HVAC Outlet Duct Upgrade

Classification:	Parts Bulletin	Section/Group:	18 - HVAC	Country/Region:	Global
Year:	All	Model:	Roadster	Version:	All

Figure 4

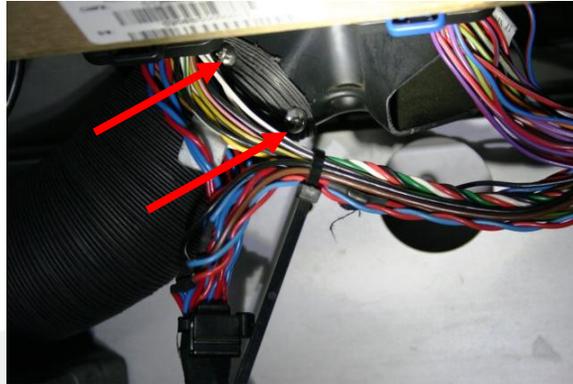
6. Tighten the screws until the tube is secure and flush with housing (Figure 4).

Figure 6

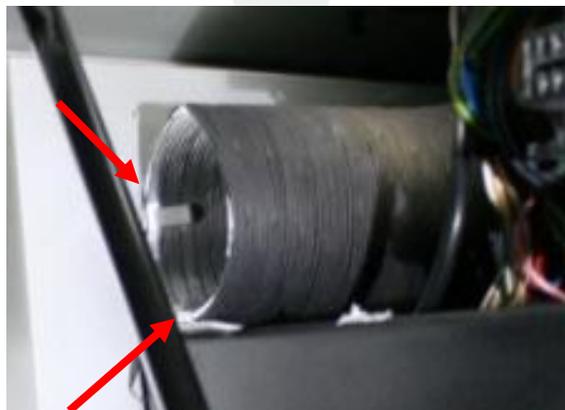
8. One mounting clip is placed horizontally and the other mounting clip is secured to chassis tub wall. Secure each mounting clip with the self adhesive base and bend clip tabs to secure duct tube (Figure 6).
